PREPARED FOR:
J.M.B. MILL CREEK L.L.C.
 5091 NEW BAUMGARTNER ROAD
 ST. LOUIS, MISSOURI 63129
 PHONE: (314) 487-6717

PROJECT: **ESTATES VILLAS AT HIGHGROVE**
 SHEET TITLE: **SITE PLAN**
 NO. **98 02 036**
 M.S.D. SHEET **8**
 OF **33**

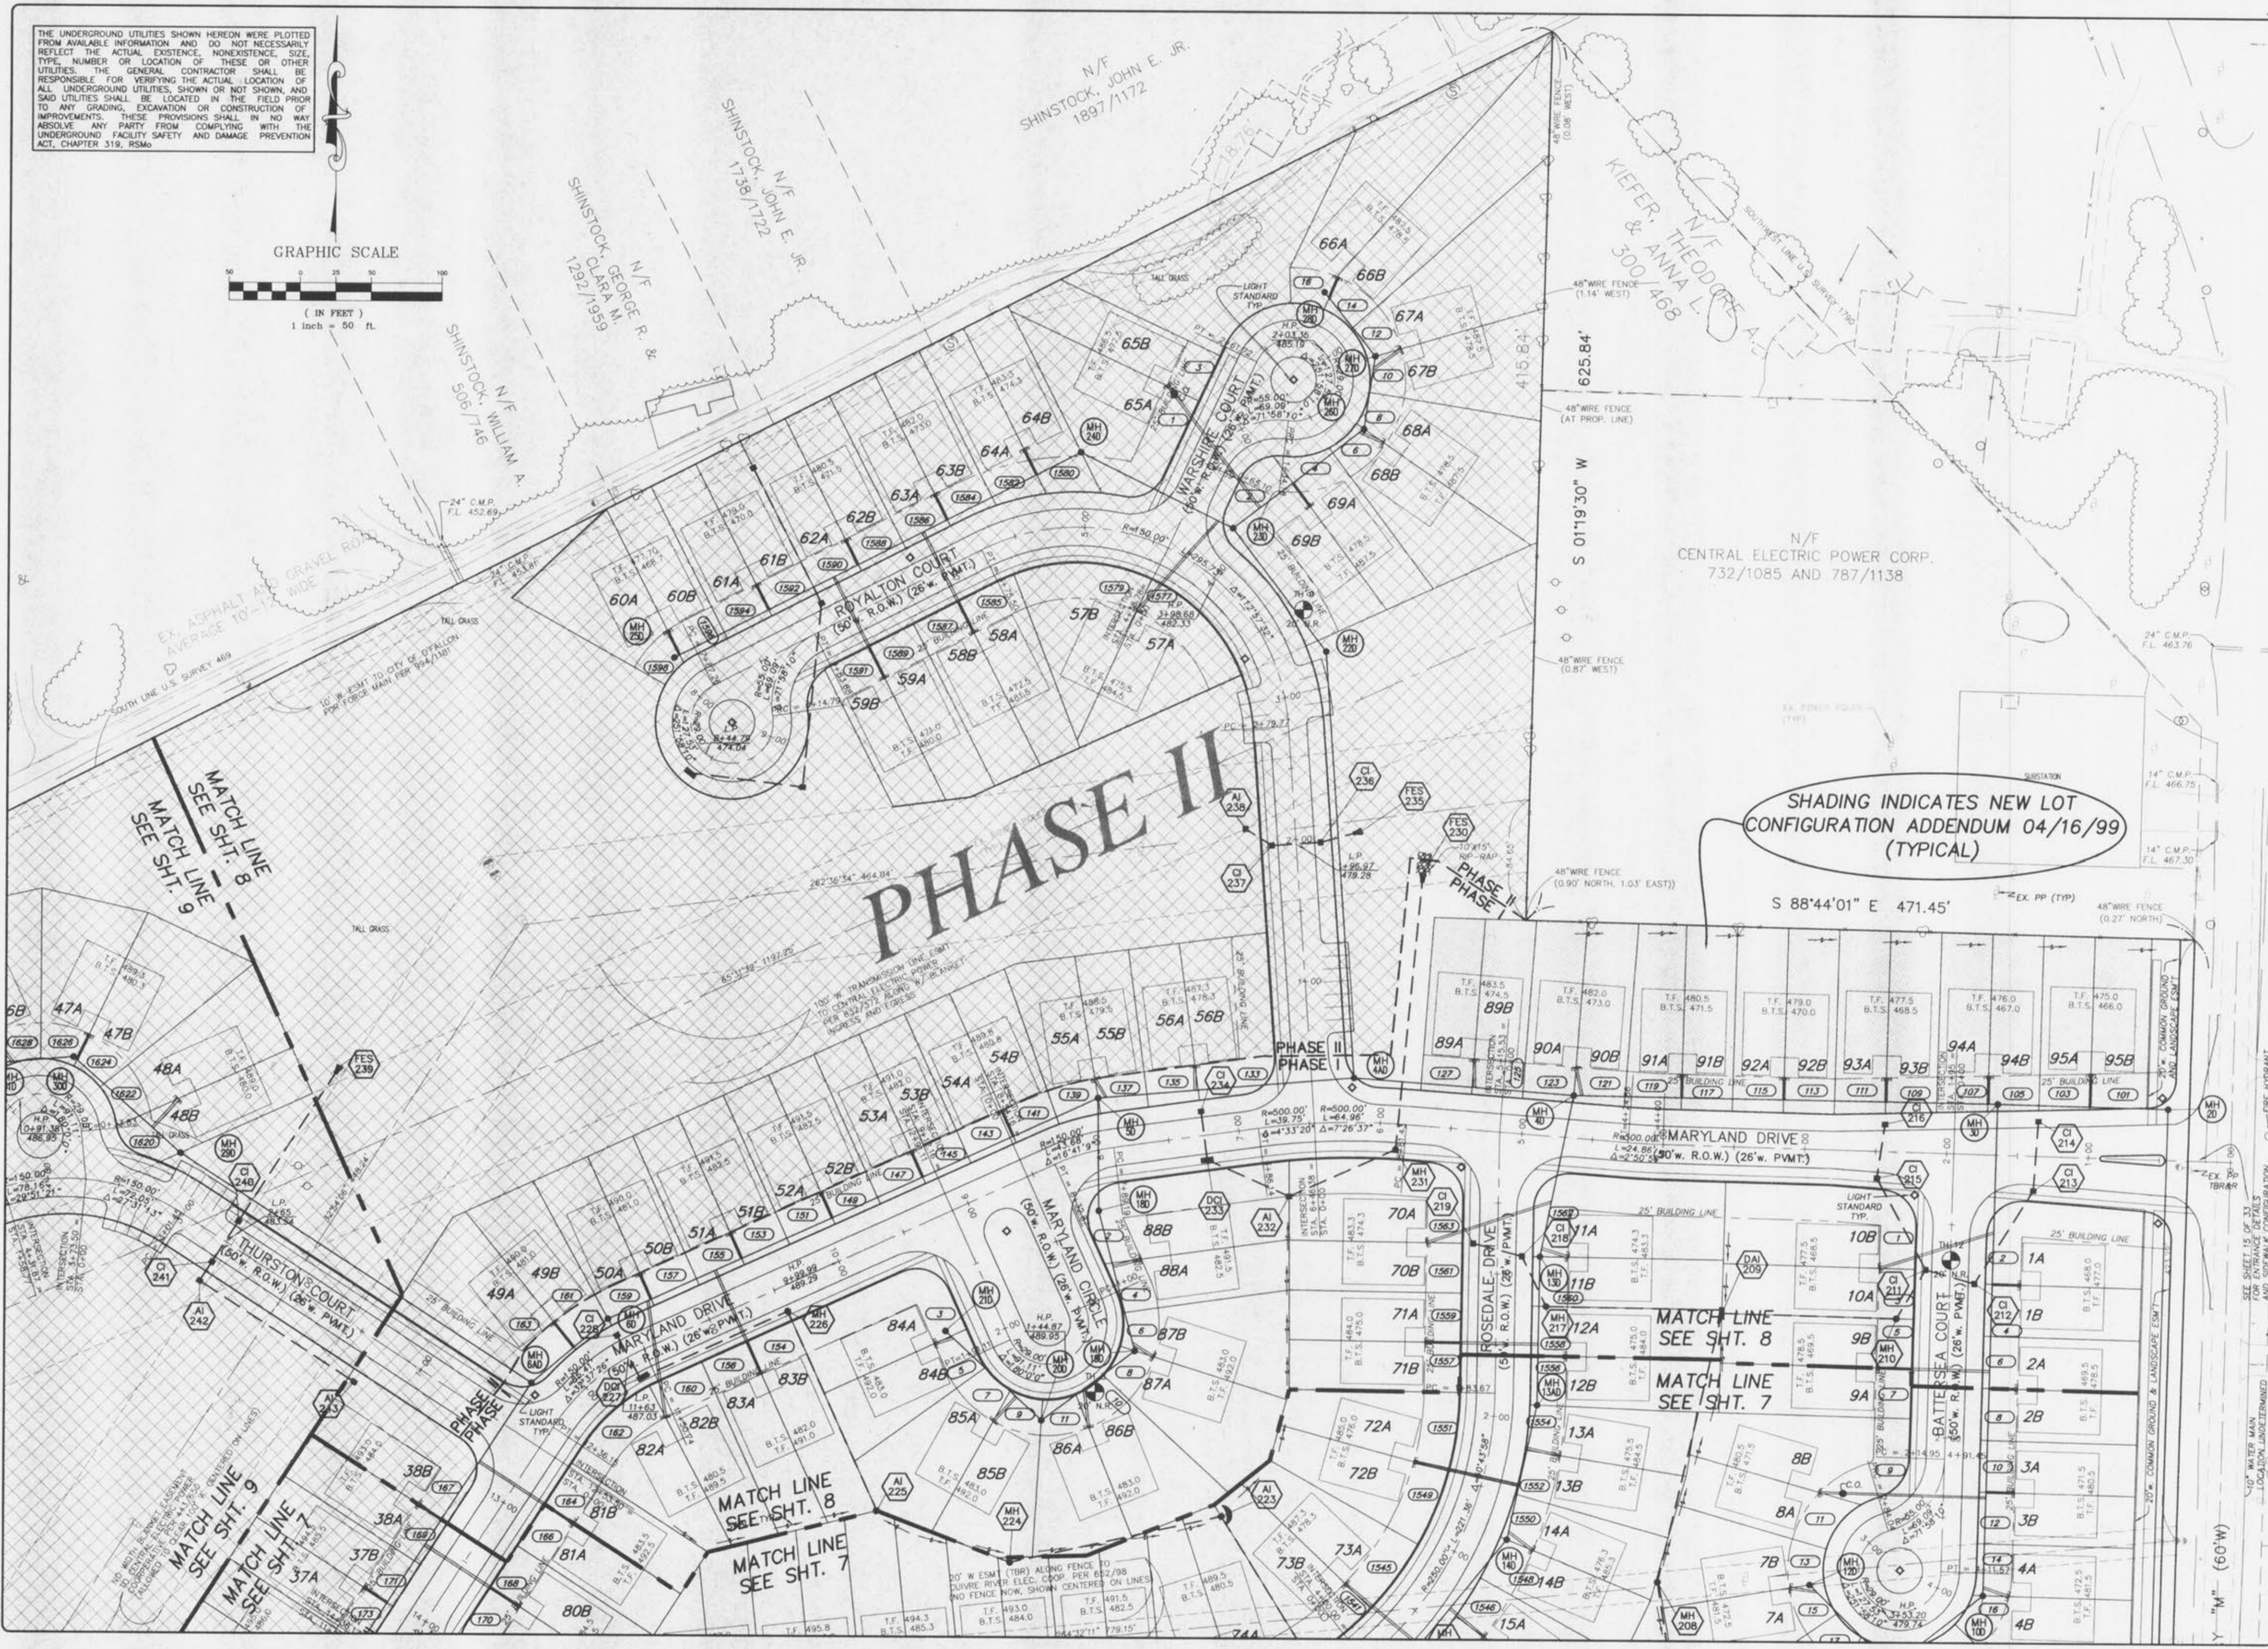
SHADING INDICATES NEW LOT CONFIGURATION ADDENDUM 04/16/99 (TYPICAL)
